Civic Design Review - Combined Phase 1 and Phase 2

BAY CORRIDOR TRANSMISSION & DISTRIBUTION (BCTD) - PHASE 3 PROJECT ELECTRICAL SUBSTATION 398 QUINT STREET

August 17, 2020

CIVIC DESIGN REVIEW (CDR), CONCEPTUAL DESIGN REVIEW COMMENTS (8.19.2019)

SOFTEN THE IMPACT OF THE WALL

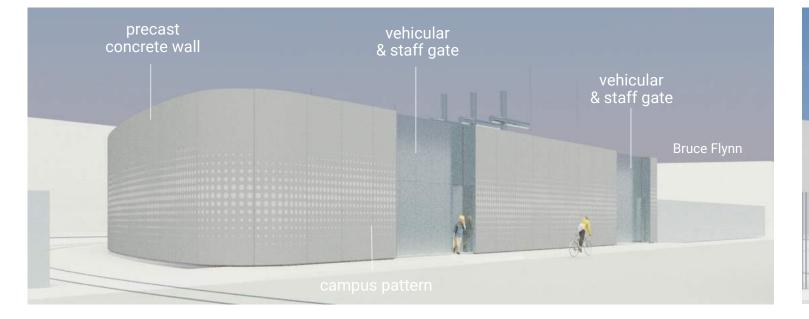
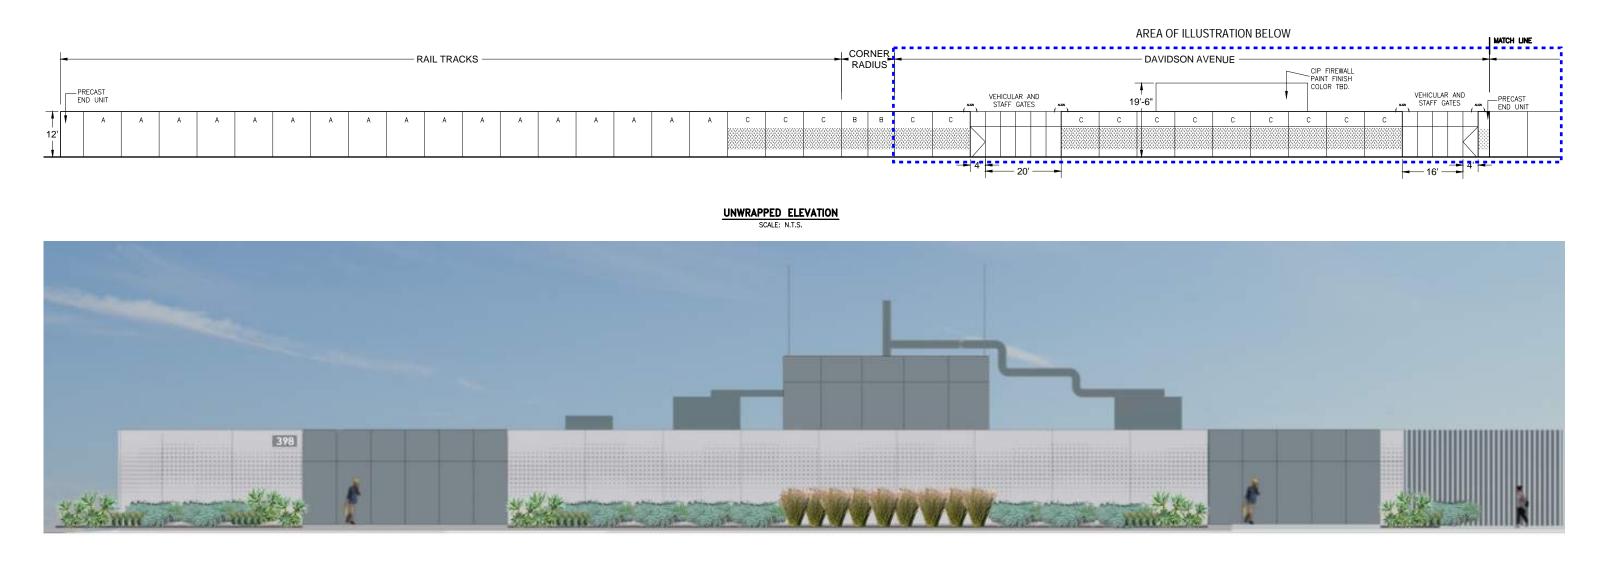
The Committee was concerned about the tall height of the wall, and suggested that the team soften its impact with more visual interest through landscaping or a green wall. The Committee suggested trees that could shorten the appearance of the wall or a frieze type element that could make the street more attractive.

Perimeter wall height has been reduced from 20' to 12' tall. accent plants at entries to create some visual interest. Trees have not been provided due to safety and security concerns. Large crane access into the facility from Davidson Avenue for maintenance.

Planting has been added as a foundation to soften the wall with

DESIGN IMPACT ALONG DAVISON AVENUE

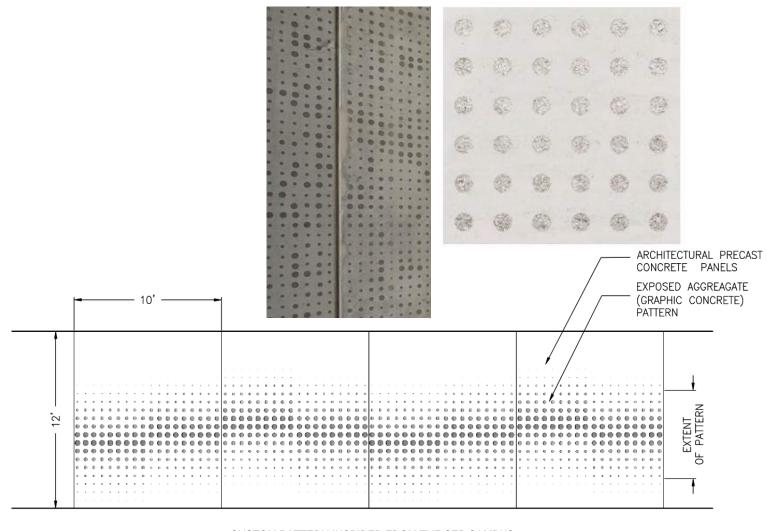
Since the Davidson Avenue street facing façade could essentially extend in the future, the Committee thought it would be important to elevate this façade and do something more industrial on the rail track façade.

Frieze type element of precast concrete panels with an enhanced surface finish pattern along Davidson Ave. Along the railroad tracks the pattern continues for 3 panels then transitions to standard concrete finish.

PRECAST CONCRETE WALL ELEVATION (DAVIDSON AVE.)

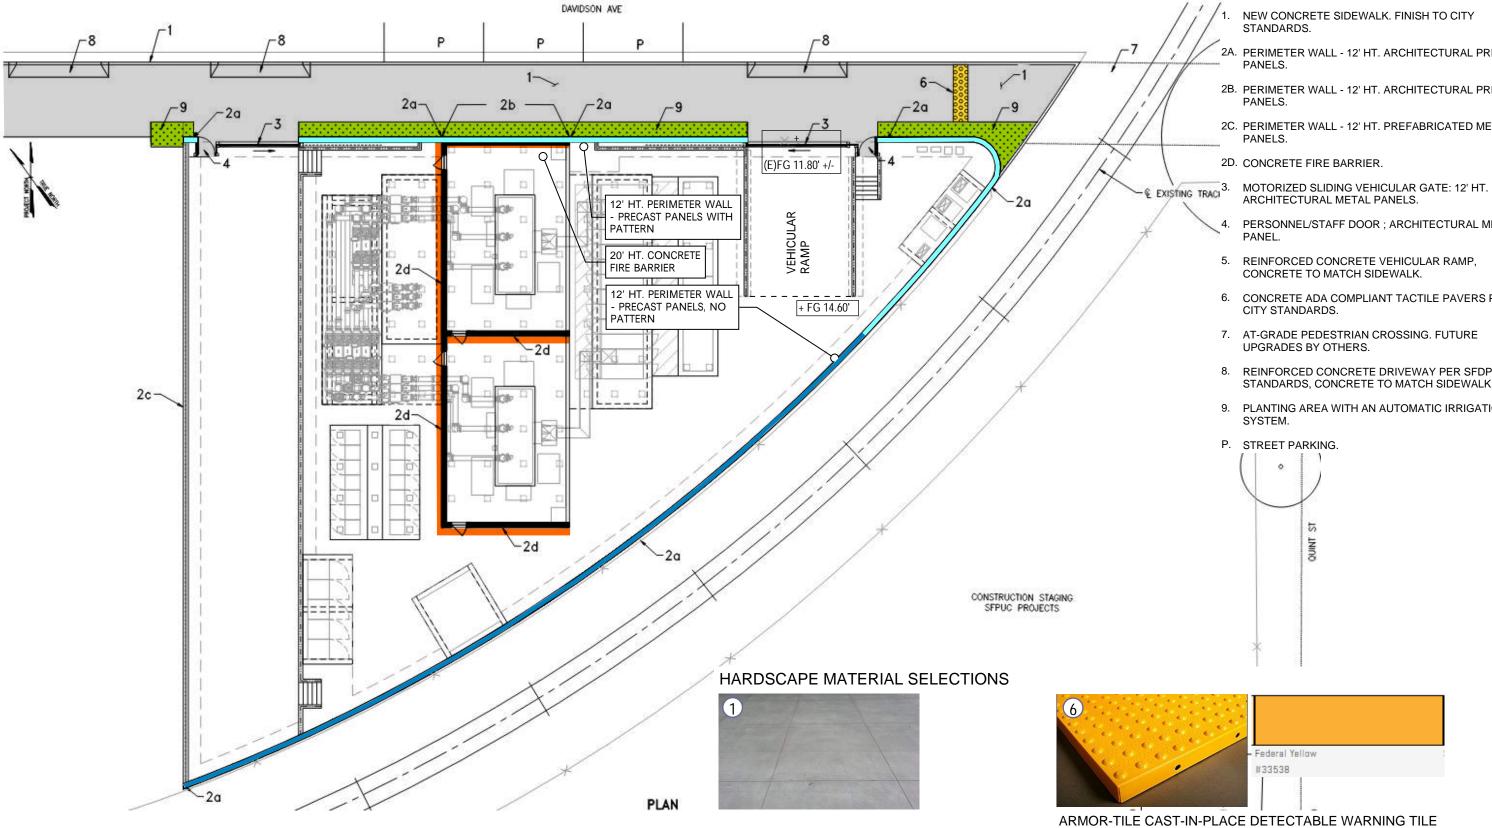
The Committee suggested looking at the nearby facilities and how the façade could be treated in color, texture, and patterning to relate to the context of the neighborhood. Committee asked for renderings with more context for the next review.

Material colors, patterns and textures have been carefully selected to reflect the surrounding industrial context, Campus and Headworks.

specifically concrete and steel in variations of gray similar to the Bruce Flynn Pump Station, the "dot" pattern is inspired from SEP
